North Luton - JLAF Aspiration for Non-Motorised User Access

The Luton and Central Bedfordshire Joint Local Access Forum (JLAF) met in January 2016 to review the proposals to develop land to the North of Luton. Subsequently this paper was agreed by the JLAF on 2nd March 2016. The document captures the JLAF's vision of an effective network of routes for non-motorised users (NMUs) to enable good access to green space within and around the development together with support of vehicle free movement to employment, shops and schools. Our aim is that the document to be shared with planners and developers to inform their plans. Our response to any proposals presented for consultation will be based on this vision.

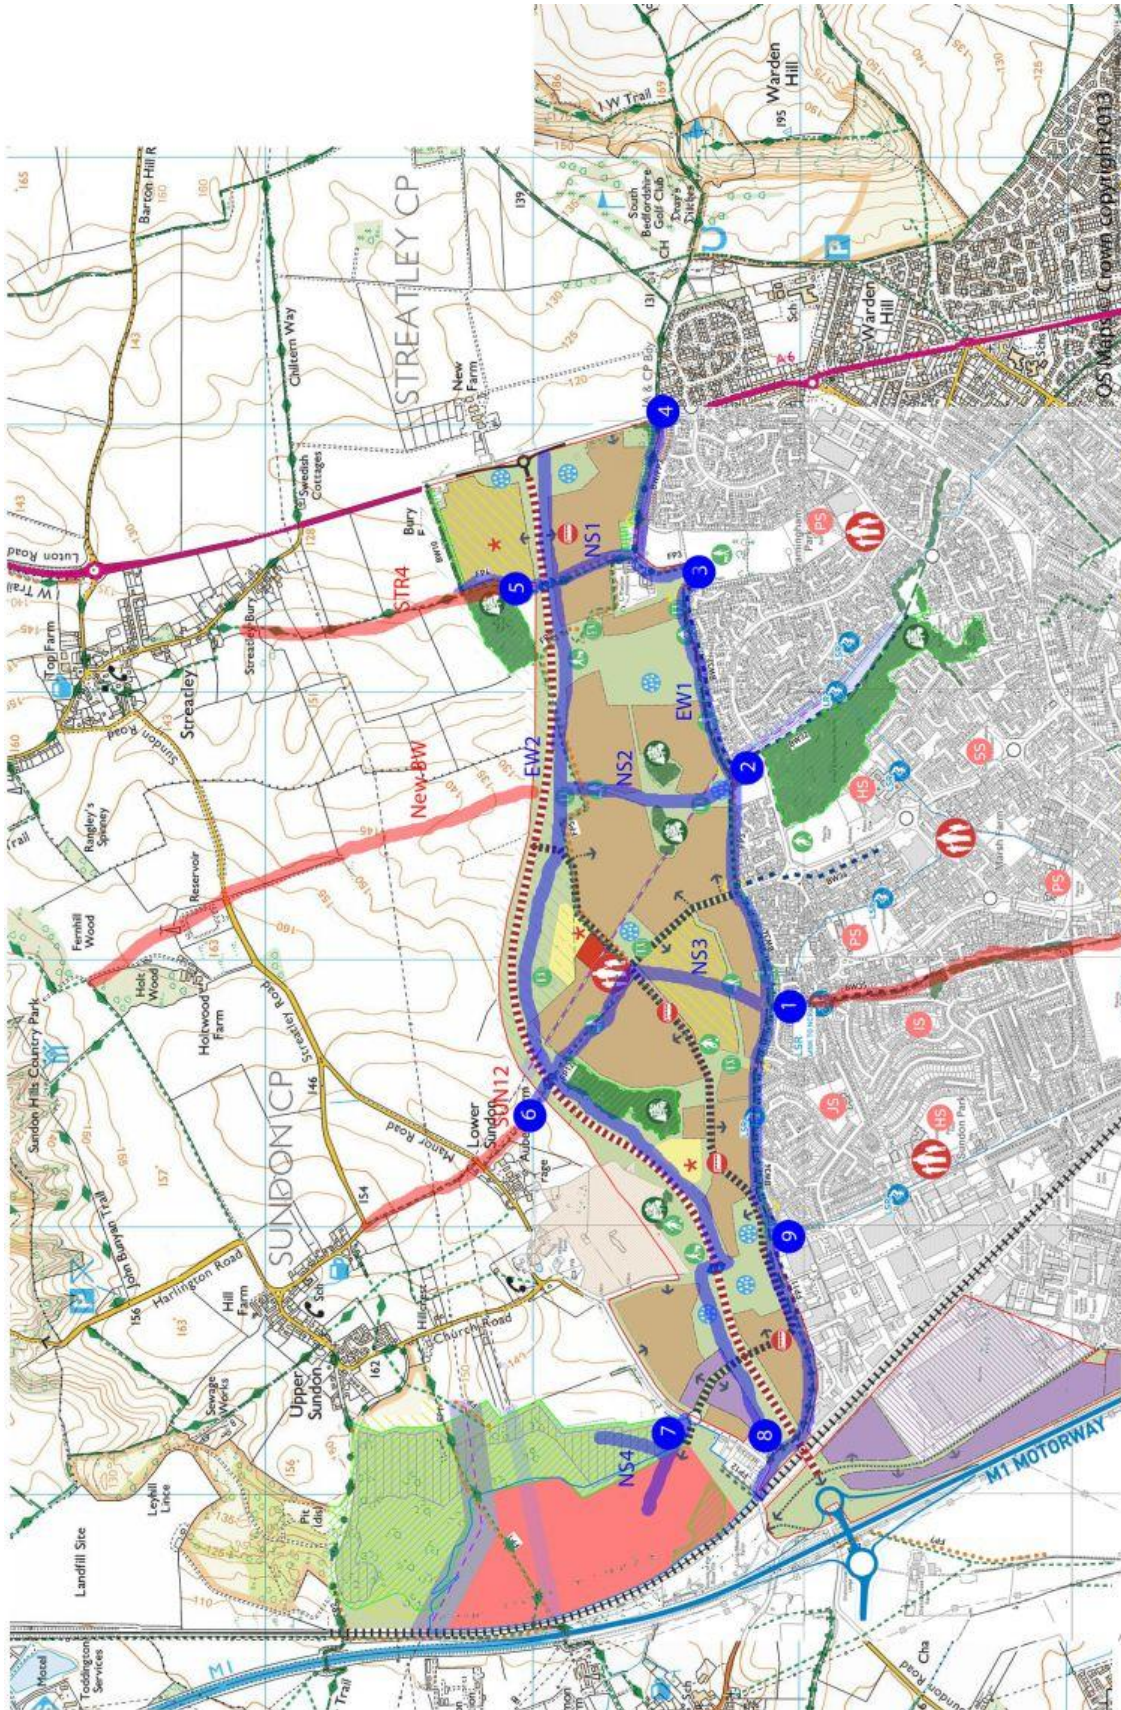
1. BW35 connection to NCR6 is an important link for NMUs
2. BW32 runs along one side of Great Bramingham wood and can be used as a cycle route to the A6 near Cowslip meadow and to access the Bramingham park shops

3. Access to the green fields of Great Bramingham park and to the shops beyond
4. There needs to be a safe A6 crossing for NMUs including horses
5. STR4 running past George Wood to Streatley and beyond that to Sharpenhoe Clappers

6. SUN12 past Sundon Wood to Upper Sundon and beyond that to Sundon Hills Country Park
7. Sundon Quarry access. This is existing Open Access land. Despite many ‘desire routes’ there is currently no official access from the south (north Luton).

8. The west end of the Theedway joins the Sundon Road to cross the railway and M1. From there you can join the Boundway south of Chalton which provides access to the open country to the west of the motorway and to Houghton Regis and Dunstable.

9. Sundon Park road provides access to Sundon Park employment area and shops/schools.

East end of EW1 (point 4) provides NMU links to Warden Hills and the countryside beyond. The west end (point 8) of EW1 provides access across the railway and M1 where there is a connection to the Boundway, a byway continuing west on the chalk ridge.

- Safe crossing of the A6 (point 4). This is, and will continue to be, a heavy traffic road so a Pegasus crossing is essential.
- Safe crossing of the spine road at Northwell Drive and Sundon Park Road
- Currently in Camford Way the bridleway runs to the south of the road and so crosses the vehicle entry to several businesses. Space should be made in the green edge of the development to provide a route to the north of the road away from road traffic.
- Where the existing byway passes under the proposed new M1/A6 link road the bridge needs to have sufficient height for all NMU users
- The M1 and railway bridge crossing (point 8) need to be safe for NMUs

Key Linkage (point 4): Access to the A6 which has a good cycleway down the east side and across the road to a bridleway leading to Warden and Galley hills. There needs to be a safe A6 crossing for NMUs including horses. The CBC/Luton boundary is close, so the crossing may be in Luton Borough.

Key Linkage (point 8): The byway at the west end of the Theedway (CHL10) joins the Sundon Road to cross the railway and M1. From there you can join the Portway south of Chalton which provides access to the open country to the west of the motorway or to Houghton Regis and Dunstable. The Boundway byway (CHL9) continues west as a byway providing NMU access. The railway and M1 result in a limited number of NMU crossing points. The new M1 junction 11A facilities NMU to access the Sundon over rail bridge. This bridge is a narrow road bridge with a tight turn at the eastern end. To provide an effective NMU crossing there are several options:

- A new rail bridge for NMU – whilst ideal this is extremely expensive
- Utilise the existing road bridge with some traffic control. To enable NMU to use the road safely signalised traffic control to stop motorised traffic would enable equestrian users (and possible cyclists and walkers) to use the bridge without vehicle conflict.
- It is not clear if the road will continue to carry the same high level of traffic. If the road is closed at Lower Sundon by the access road to the RFI terminal then the motorised traffic will be minimal enabling the road bridge to safely accommodate limited vehicles and the NMU.
